Block(s): 16 & 17 Section: 13 District/Division: MAWSON

Issue	Date	Amendment
Project		
Multi Unit Housing		
Site		
blocks 16+17		
section 13,		
Mawson, ACT.		
Title		
Site Plan		
Scale	1:200	Drawn By SA
Date	May 2008	Drawing No. 1284 - A
PETER BYFIELD + Associates Suits A, 34 Taylor Street, Ainsworth NSW 2158 Phone 02 9880 2255 Fax 02 9660 2255

Title
Basement Level Floor Plan

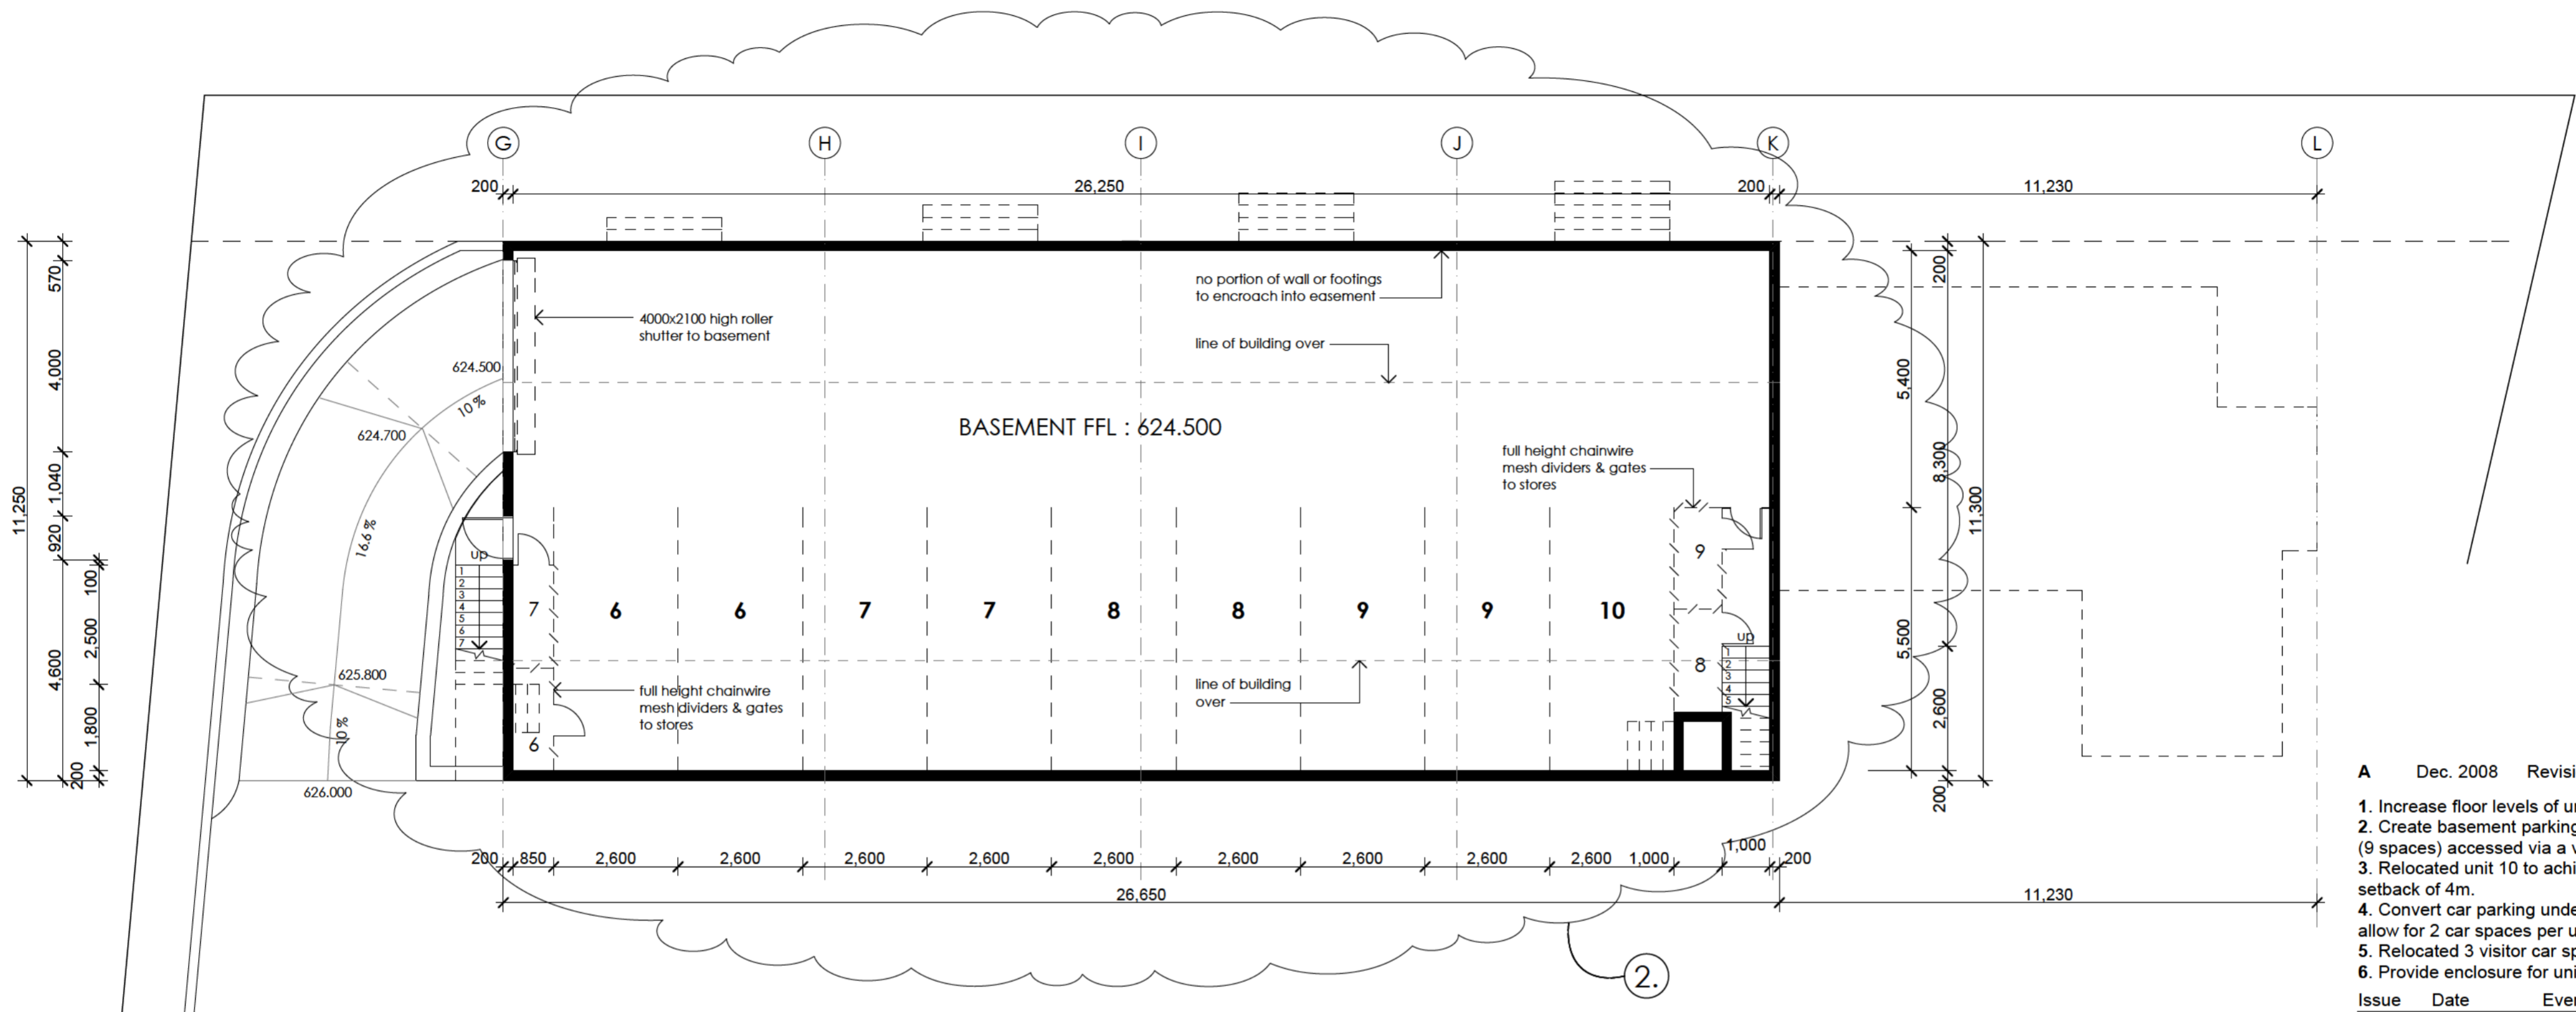
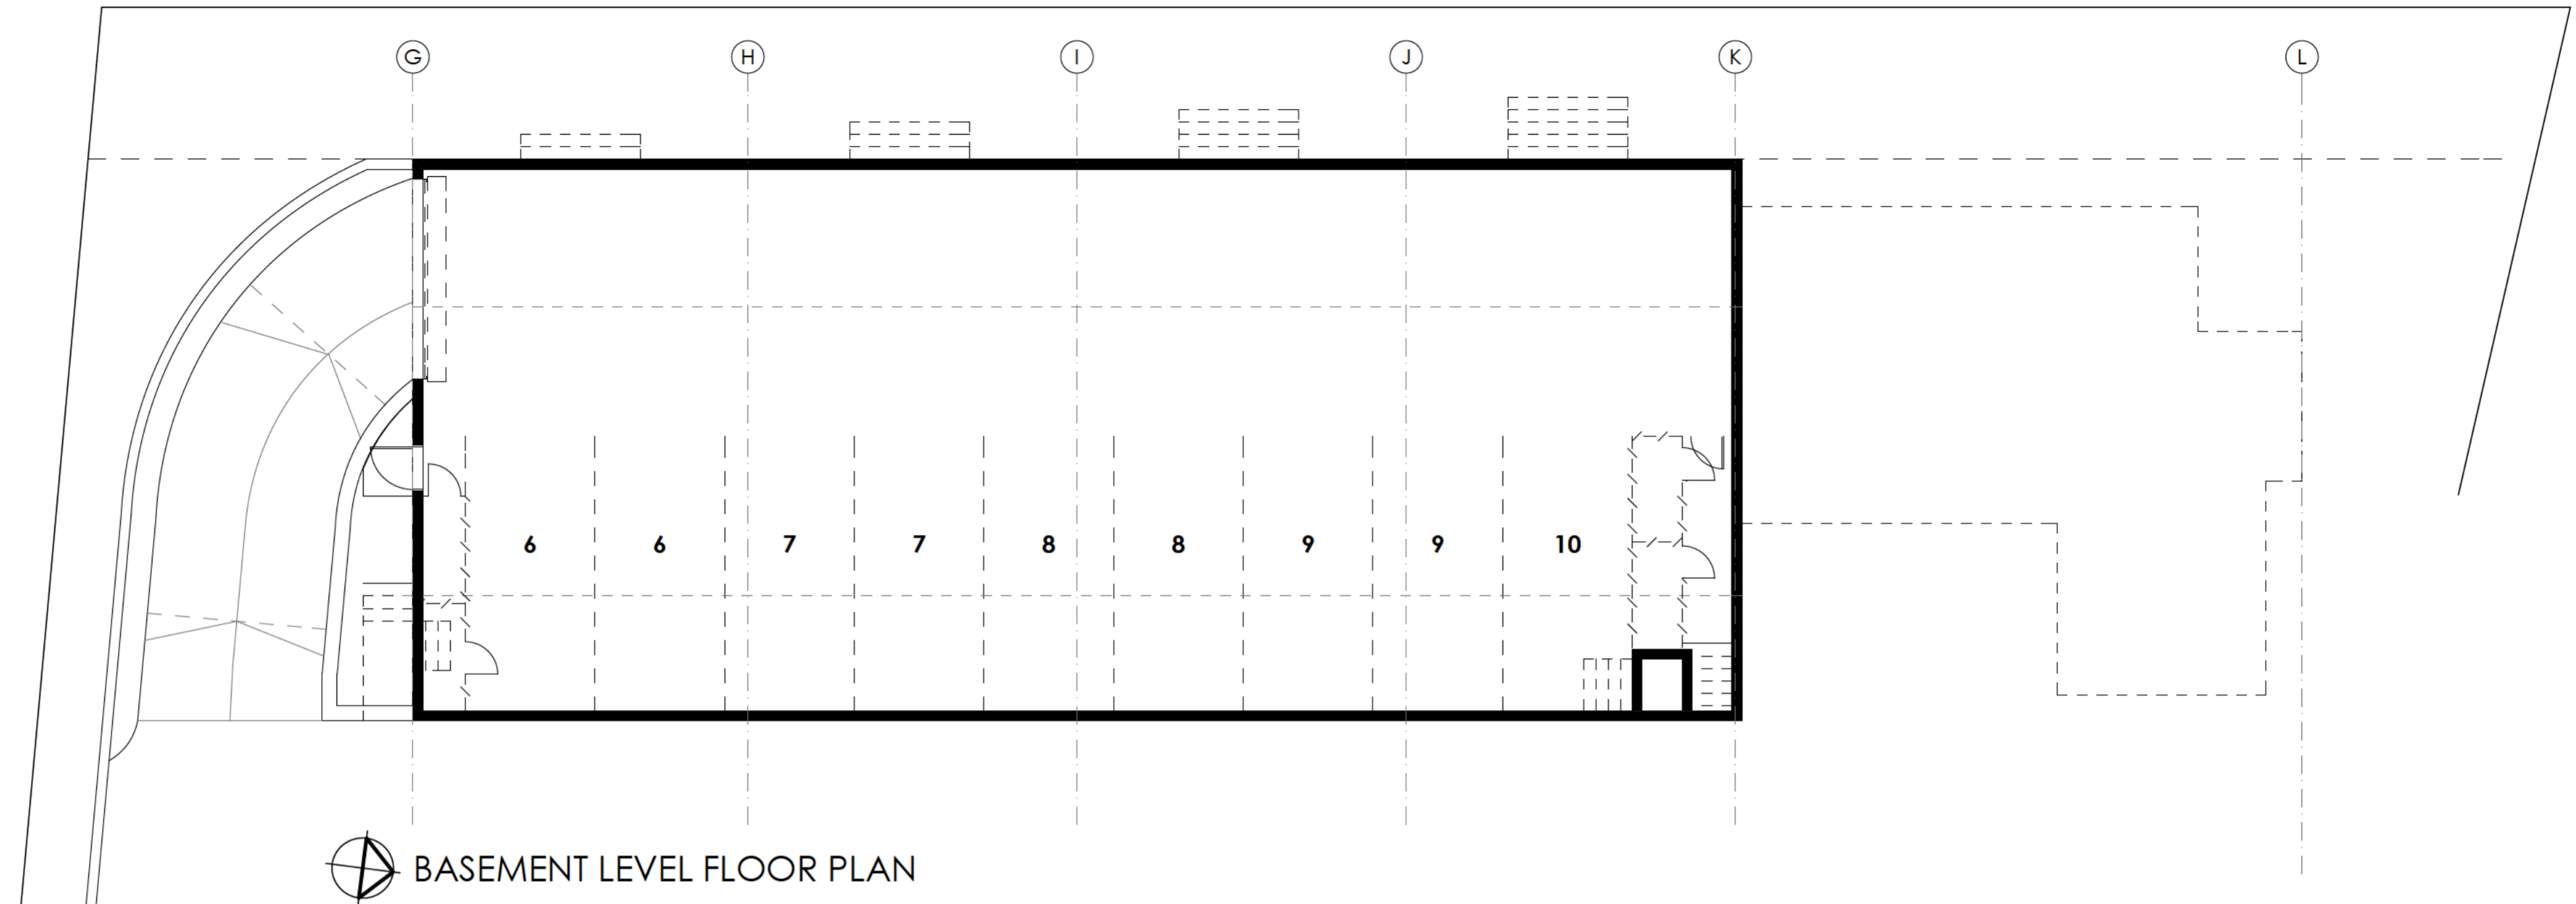
1. Increase floor levels of units 6-9 by 700mm.
2. Create basement parking under units 6-9 (9 spaces) accessed via a vehicular ramp.
3. Relocated unit 10 to achieve a rear setback of 4m.
4. Convert car parking under units 1-5 to allow for 2 car spaces per unit (1-5).
5. Relocated 3 visitor car spaces.
6. Provide enclosure for units 6-9 waste bins.

Title
Neighbour Notification Plan
Basement & Garage Level

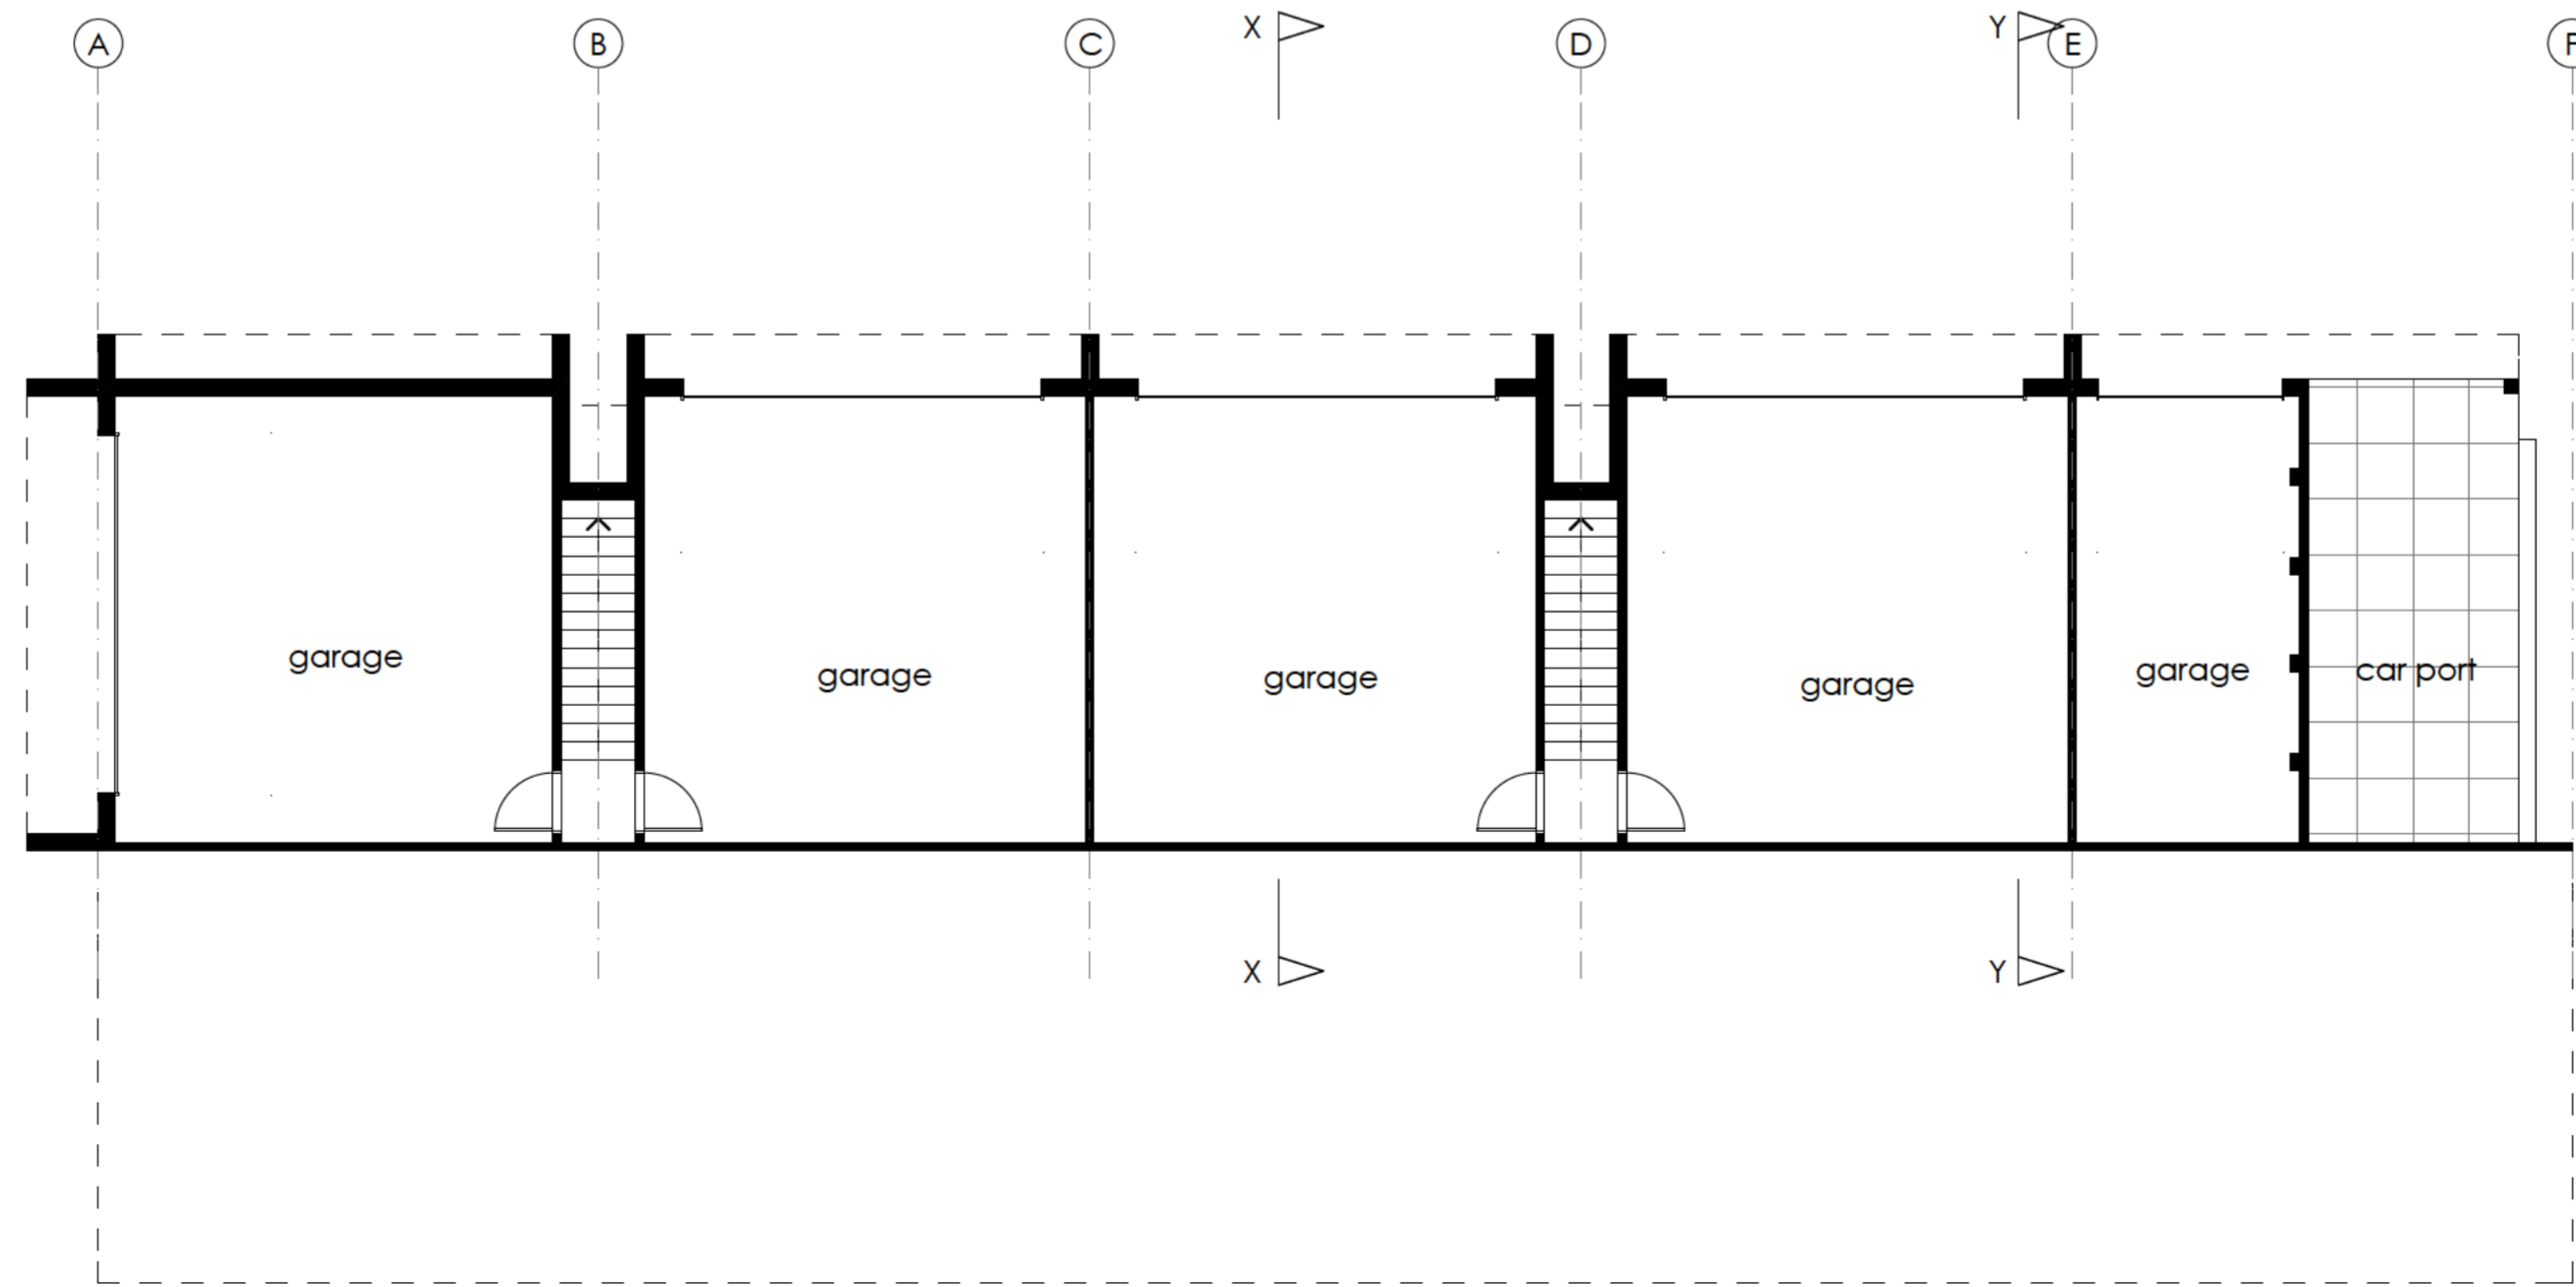
1. Increase floor levels of units 6-9 by 700mm.
2. Create basement parking under units 6-9 (9 spaces) accessed via a vehicular ramp.
3. Relocated unit 10 to achieve a rear setback of 4m.
4. Convert car parking under units 1-5 to allow for 2 car spaces per unit (1-5).
5. Relocated 3 visitor car spaces.
6. Provide enclosure for units 6-9 waste bins.
